FORD 4R100 "UPDATE HANDBOOK"

FORD 4R100 "UPDATE HANDBOOK"

Since the introduction of the 4R100 transmission in model year 1998, there have been many engineering changes to improve Pleaseability, Reliability and Durability concerns. These changes have affected most every part used in this transmission. This "Update Handbook" will explain each change, the reason for the change, and any parts interchangeability concerns created by the change, along with any part numbers needed to update your transmission.

Figure 2

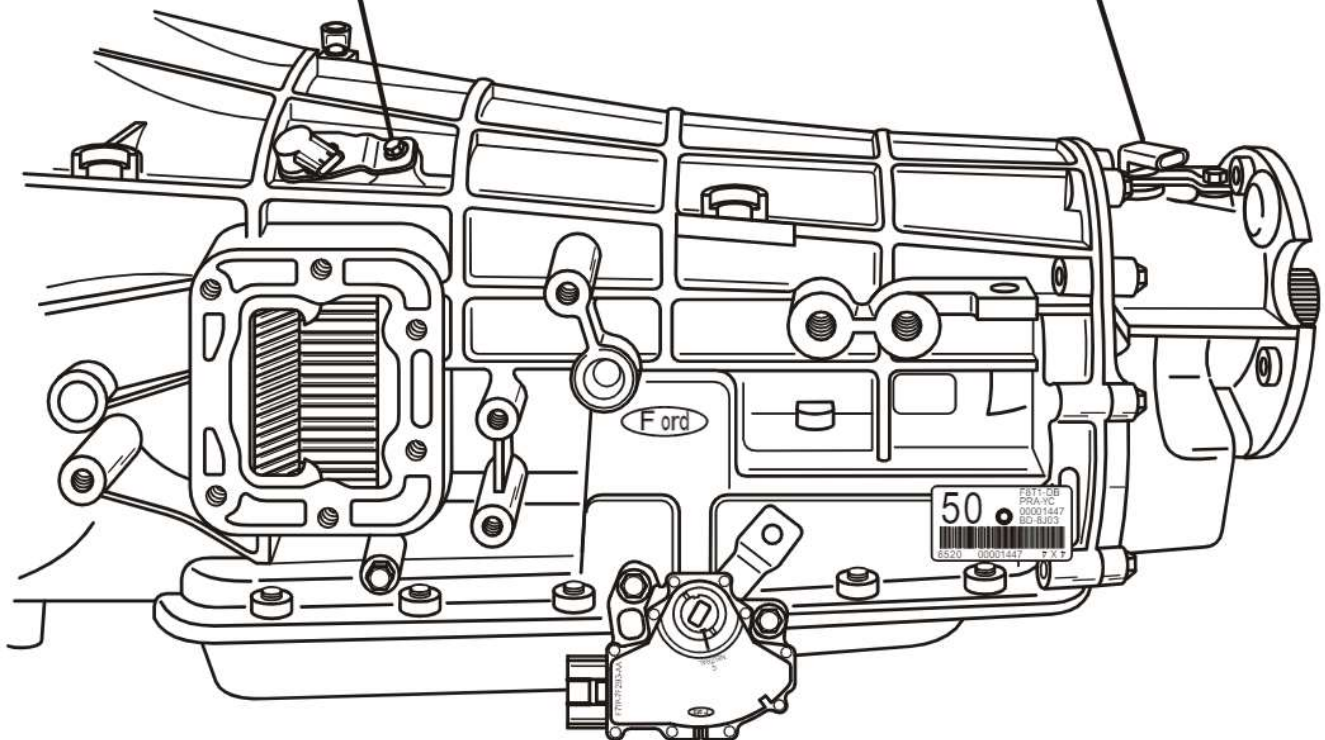
- (2) **TURBINE SPEED SENSOR** - Added to the top front of the case on some models, as shown in Figure 2. We have also provided you with the resistance readings and OEM part numbers on both Turbine Speed Sensors, as the PTO and Non-PTO models use different sensors. Refer to Figure 2 for turbine speed sensor information.

- (3) **OUTPUT SHAFT SENSOR** - Output Shaft Speed sensor was added to the top of the extension housing on some models, as shown in Figure 2. OSS is triggered by an added rotor pressed onto the output shaft, which requires a new tool to position the speed rotor properly *if* it is removed during overhaul, as shown in Figure 3. The park gear is also now pressed onto the output shaft, and the number 13 thrust washer has been changed to a thrust bearing as shown in Figure 3. We have provided you with the resistance reading and the OEM part number for the output shaft speed sensor. Refer to Figure 2 for output shaft speed sensor information.

*PTO Models Only = 496-1244 Ohms Resistance
Part Number F81Z-7M101-BA*

*Non PTO Models Only = 781-1979 Ohms Resistance
Part Number F81Z-7M101-AA*

*All Models = 781-1979 Ohms Resistance
Part Number F81Z-7M101-AA*

Figure 4

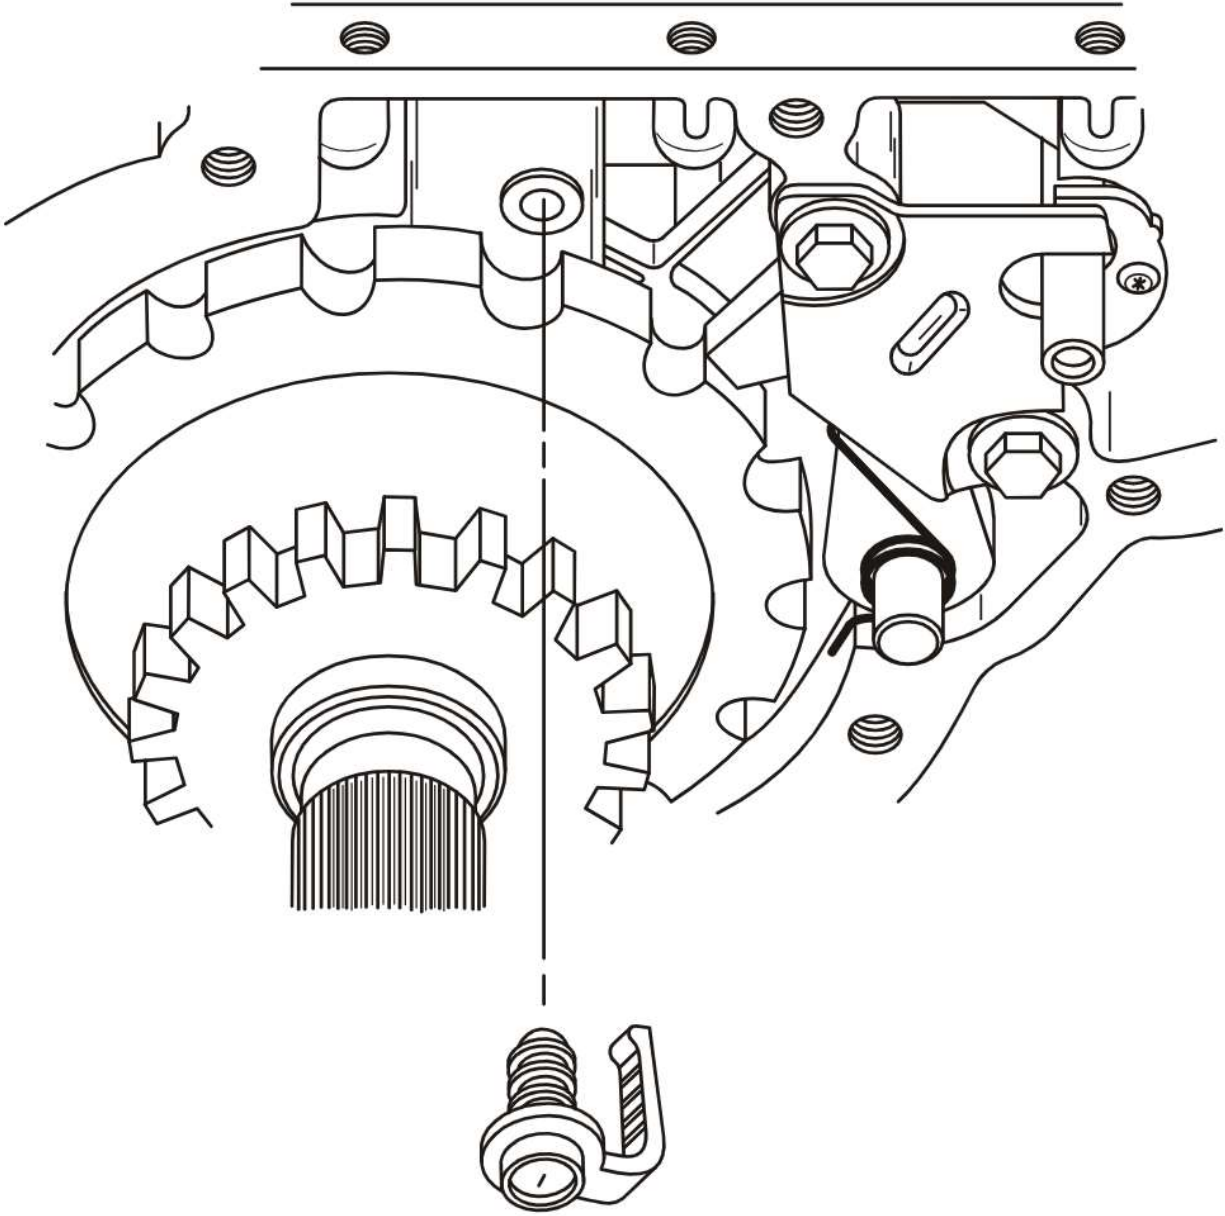
- (4) **LUBE ORIFICE PLUG** - Added to the rear of the case in the lube circuit to provide added lubrication to the extension housing bushing on 2WD models. To retain common cases the 4WD models will also have the lube orifice plug installed, as well as E4OD cases produced after July 24, 1997. Lube Orifice Plug is available under OEM part number F81Z-7E380-AA, and should be replaced on rebuild. Refer to Figure 4.

**LUBE ORIFICE PLUG
FORD PART NUMBER
F81Z-7E380-AA**

Figure 6

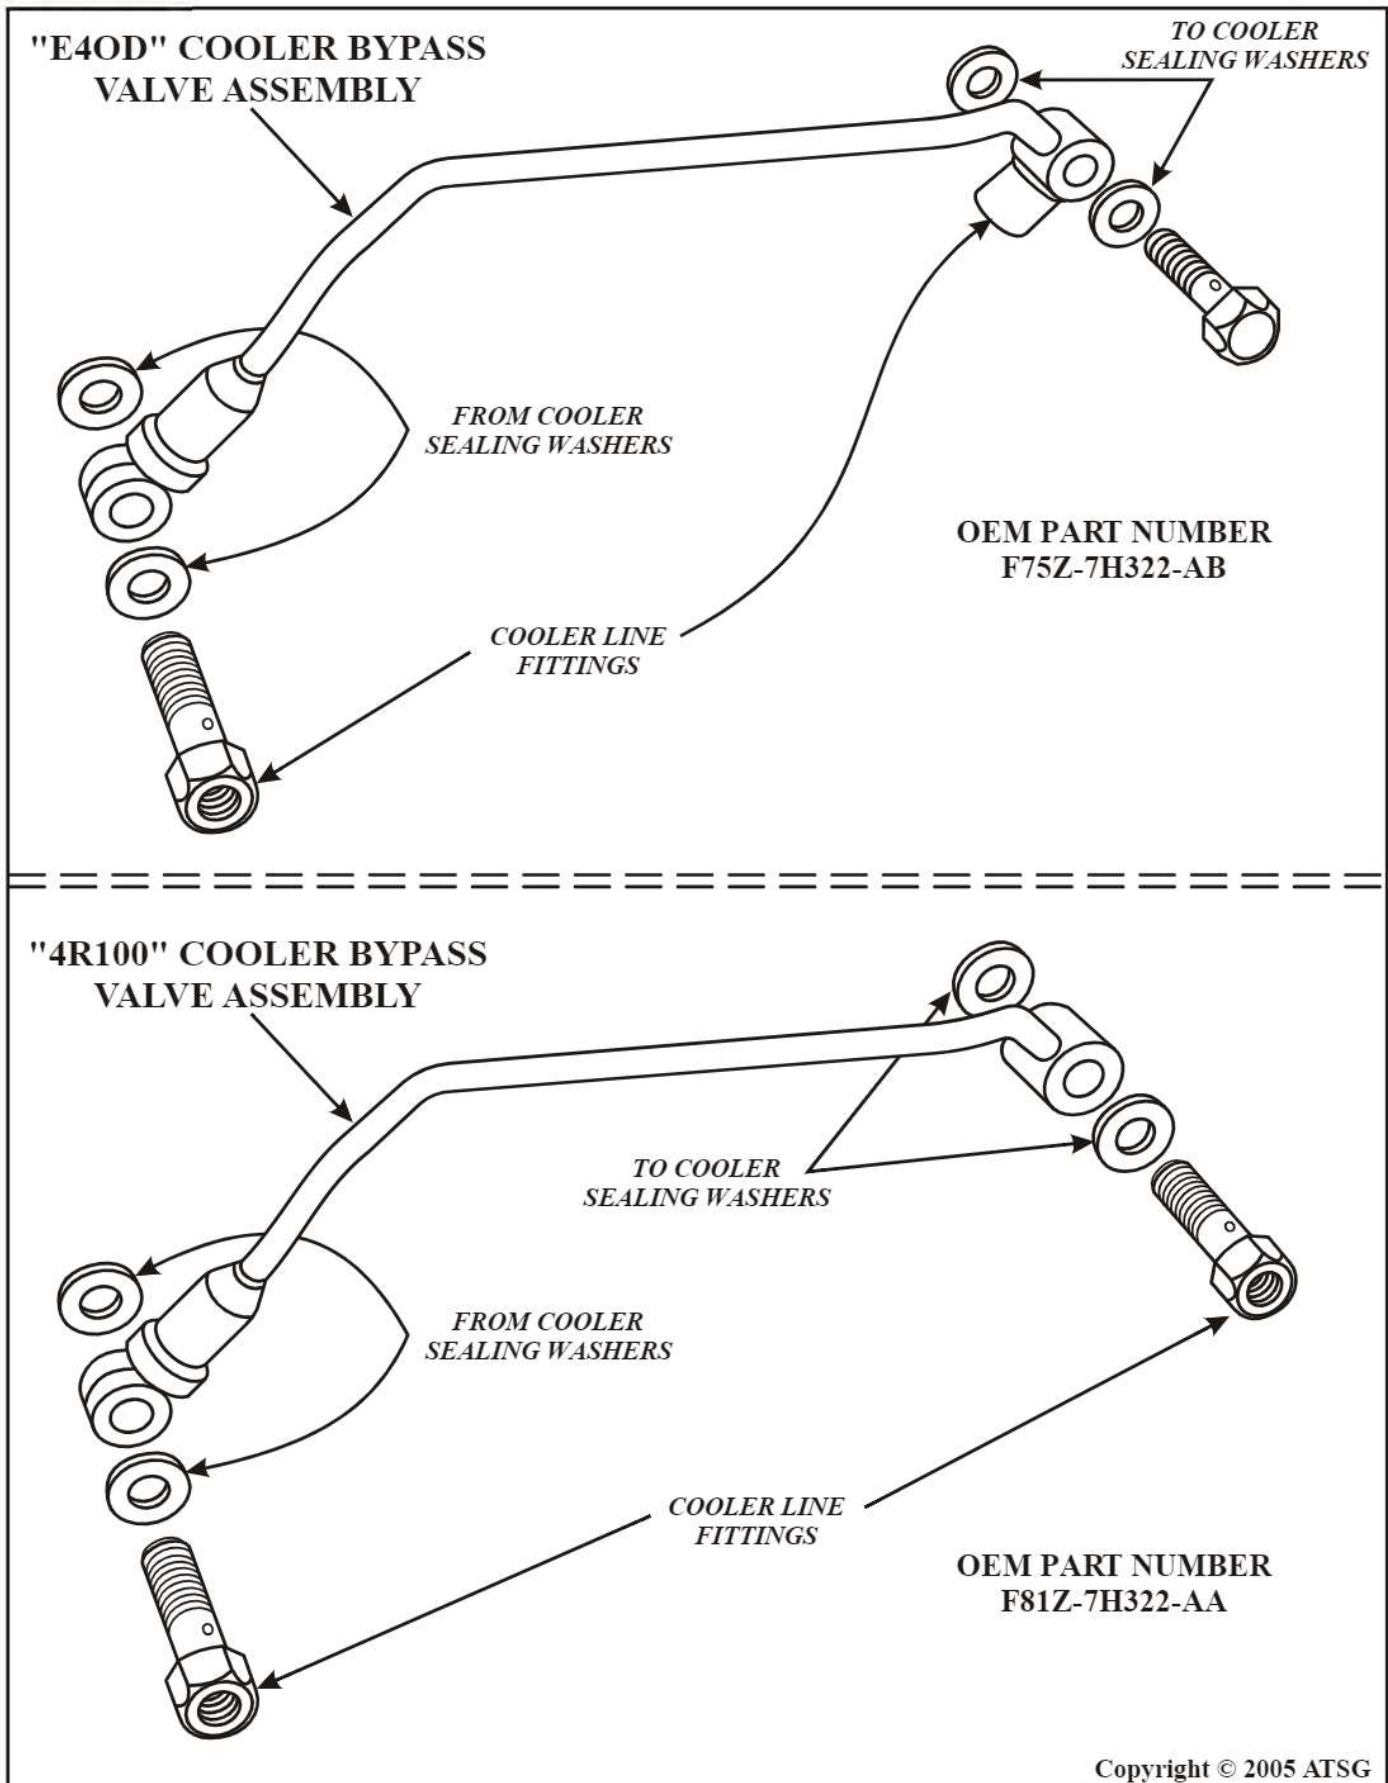
- (6) **MANUAL SHIFT LEVER** - There are two different external shift levers for this unit, one for Non-PTO transmissions and one for transmissions with the PTO option, as shown in Figure 6. We have provided you with the "Stamping" number as well as the OEM part number for both, as shown in Figure 6.

"With" PTO OPTION
STAMPED F81P-AA

FORD PART NUMBER
F81Z-7A256-AA

"Without" PTO OPTION
STAMPED F75P-BB

FORD PART NUMBER
F7UZ-7A256-BB

Figure 8

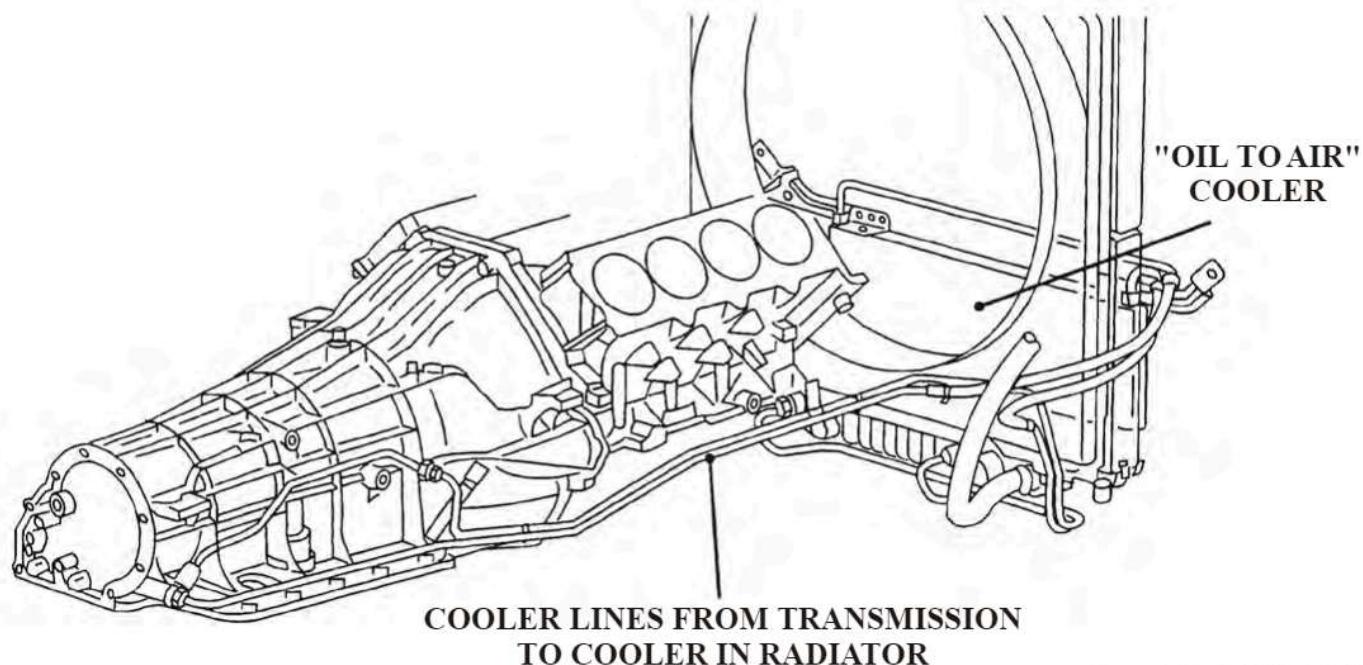
- (8) **TRANSMISSION COOLERS** - Most F-Series vehicles over 8500 GVW equipped with the 4R100 transmission have an external "Oil-To-Air" cooler *only*. Due to the internal design of the "Oil-To-Air" cooler, it cannot be adequately flushed to remove contaminants, and requires replacement during transmission rebuild. The only exception is that F-Series vehicles over 8500 GVW equipped with the 5.4L engine also uses a radiator "In-Tank" cooler in addition to the "Oil-To-Air" cooler. Refer to Figure 8 for transmission cooler information.

Most F-Series vehicles over 8500 GVW equipped with the 4R100 transmission have an external "Oil-To-Air" cooler only. Due to the internal design the "Oil-To-Air" cooler cannot be adequately flushed to remove contaminants, and requires replacement during transmission rebuild.

The only exception is that F-Series vehicles over 8500 GVW equipped with the 5.4L engine also uses a radiator "In-Tank" cooler in addition to the "Oil-To-Air" cooler.

Figure 9

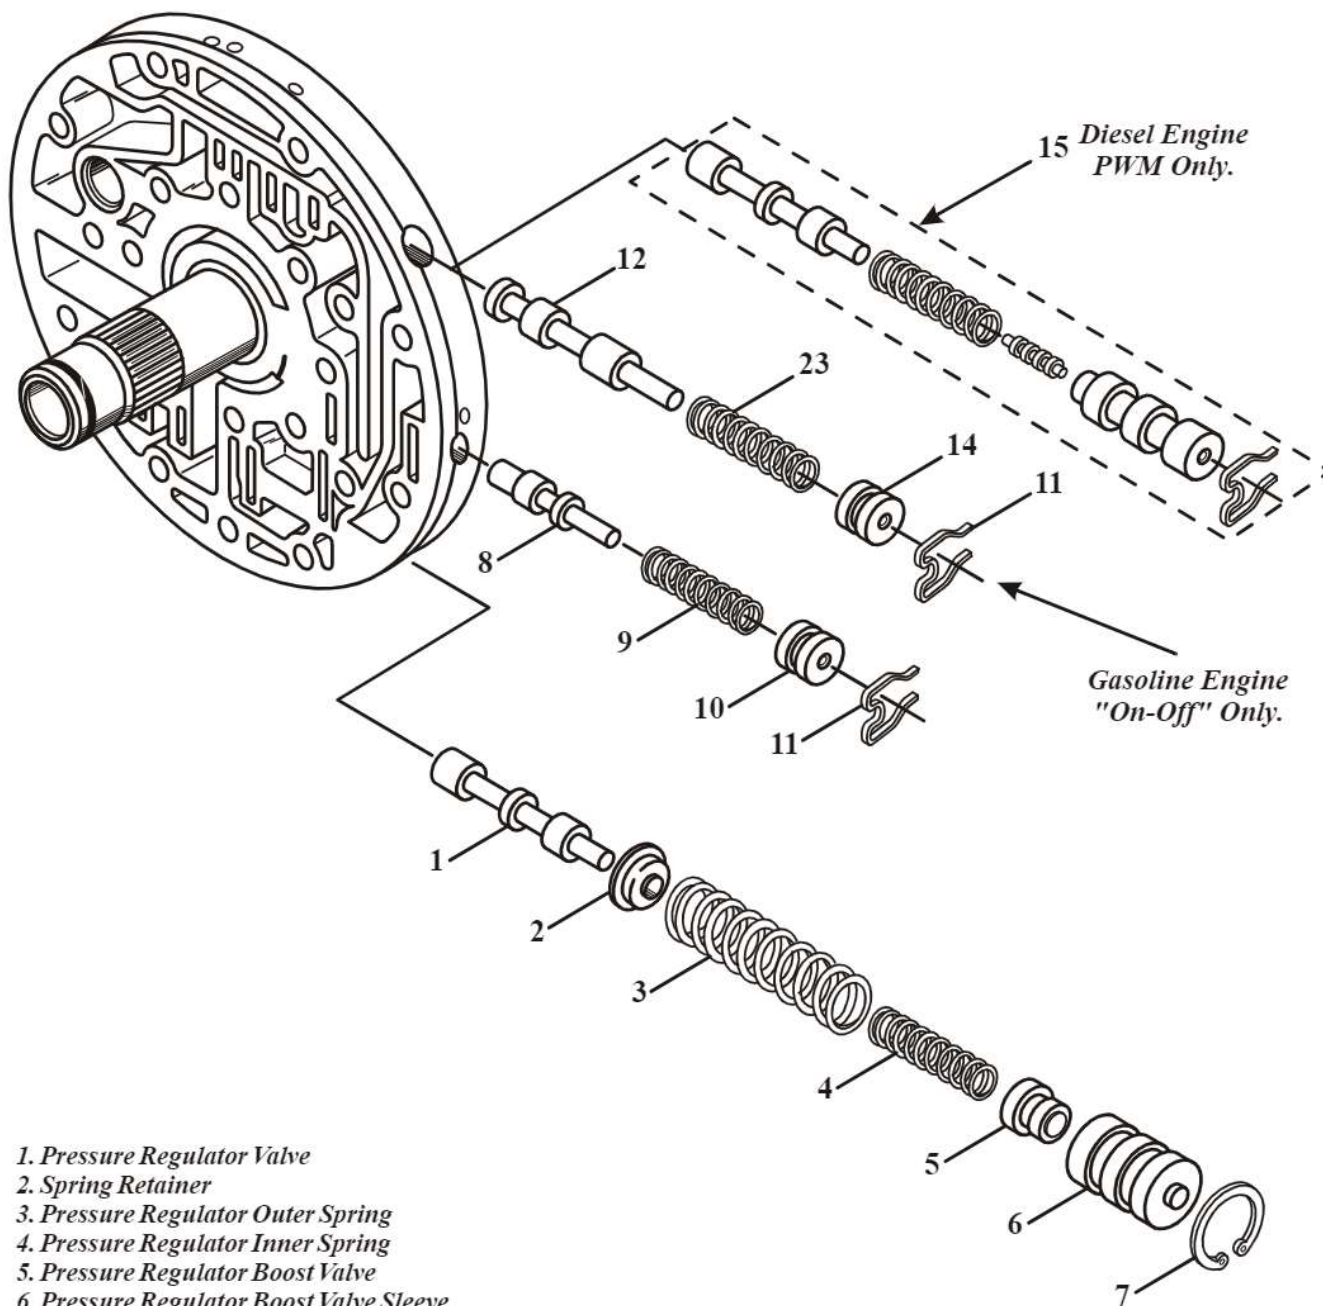
- (9) **FRONT PUMP COVER** - The pump cover is basically the same as the E4OD, but has a different valve line-up in the Converter Clutch Control Valve bore. The gasoline applications all have an "On-Off" lock-up solenoid and the 7.3L diesel applications all have a Pulse Width Modulated (PWM) lock-up solenoid. This changes the Converter Clutch Control Valve line-ups in the pump cover, as shown in Figure 9.

Figure 13

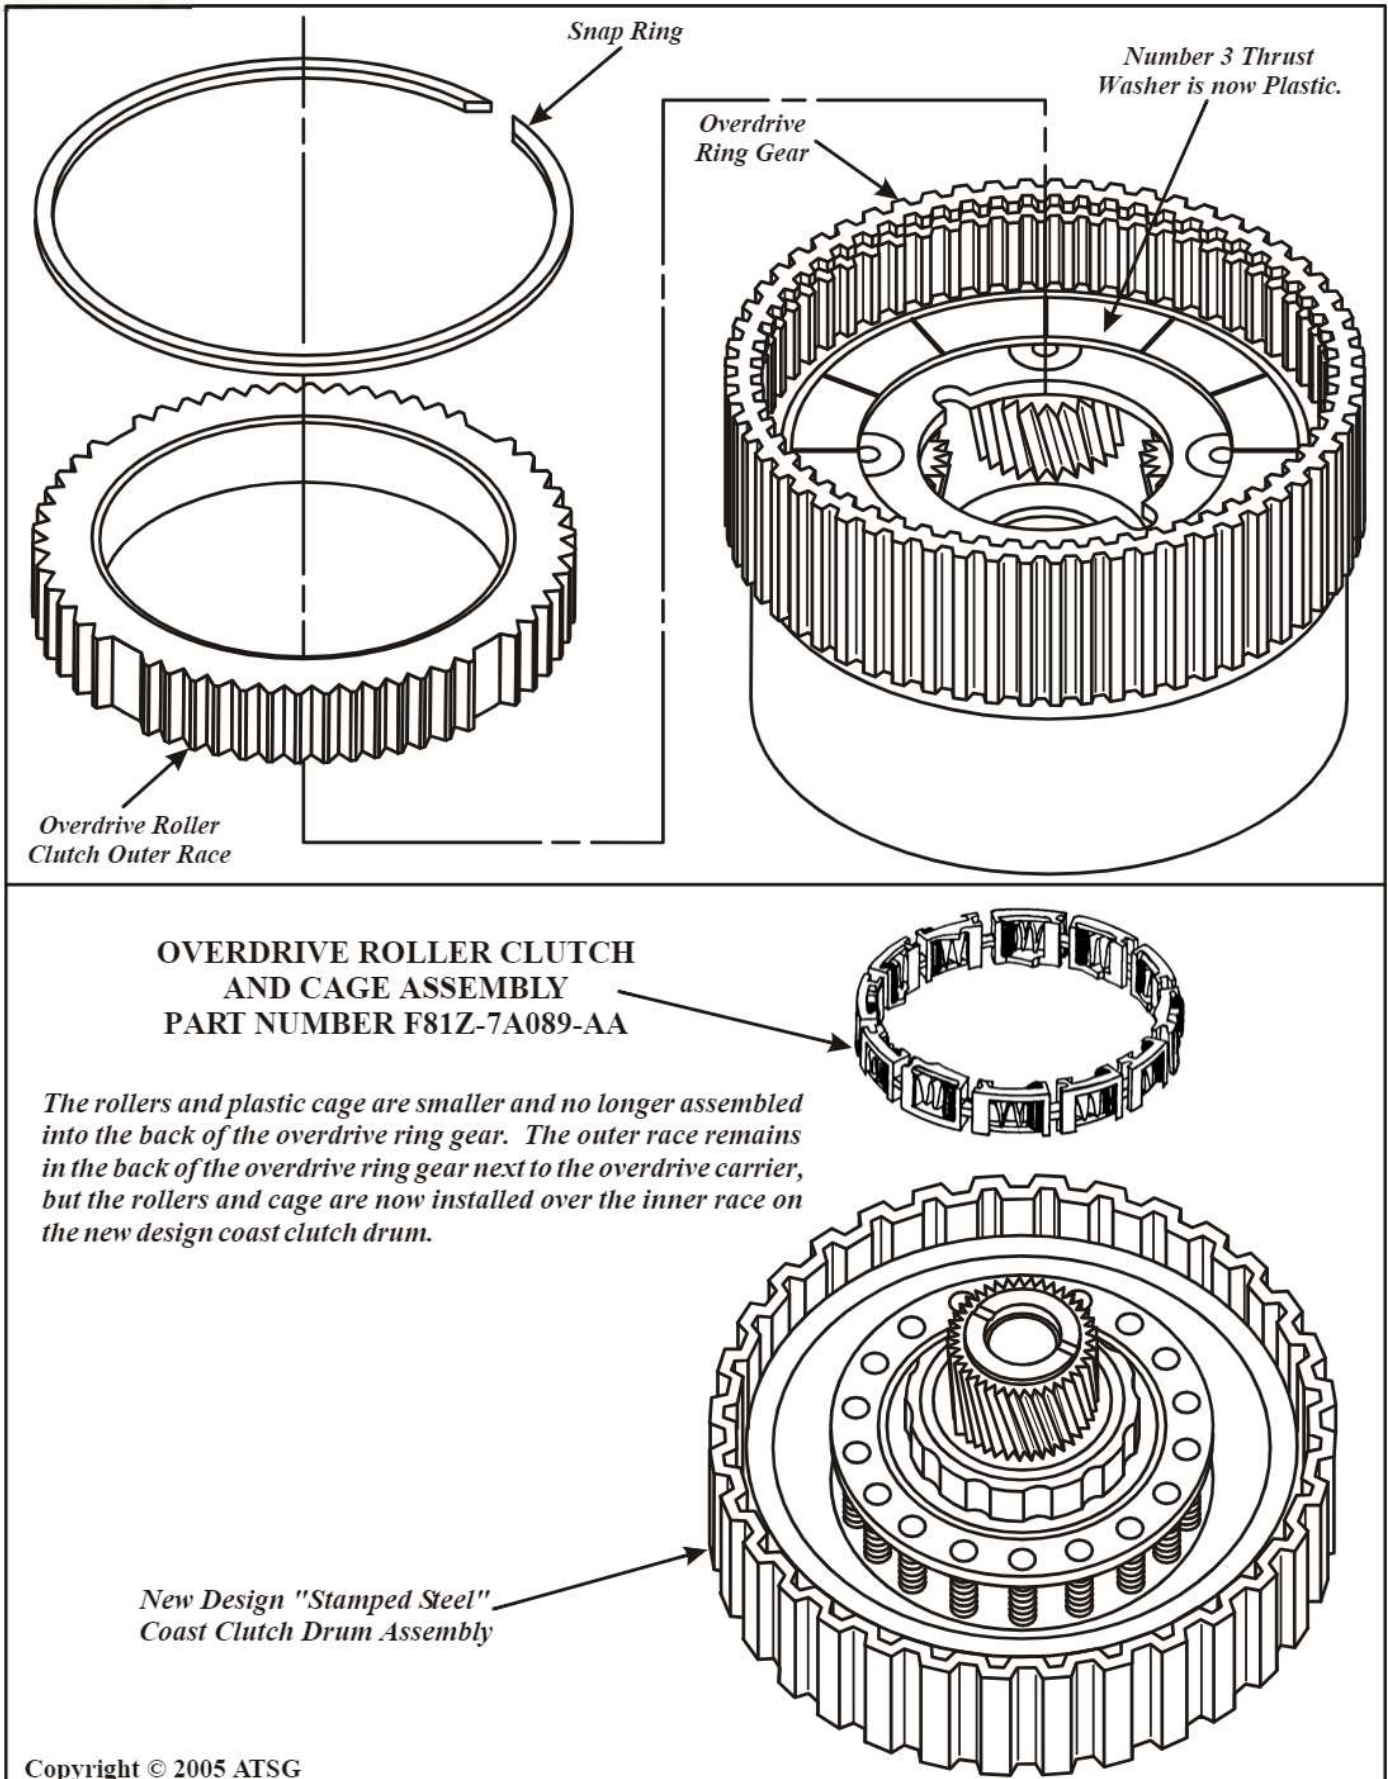
- (13) **OVERDRIVE ROLLER CLUTCH** - The overdrive roller clutch inner cam is now made onto the new design coast clutch drum, instead of being splined like the previous models were, and is illustrated in Figure 13. The new design overdrive roller clutch assembly is now assembled onto the inner cam on the new design drum. The overdrive roller clutch outer race is still located in the overdrive ring gear next to the overdrive carrier and the number 13 thrust washer between the two is now plastic, but the cage and roller assembly are now assembled over the inner race on the new design coast clutch drum. Refer to Figure 13.
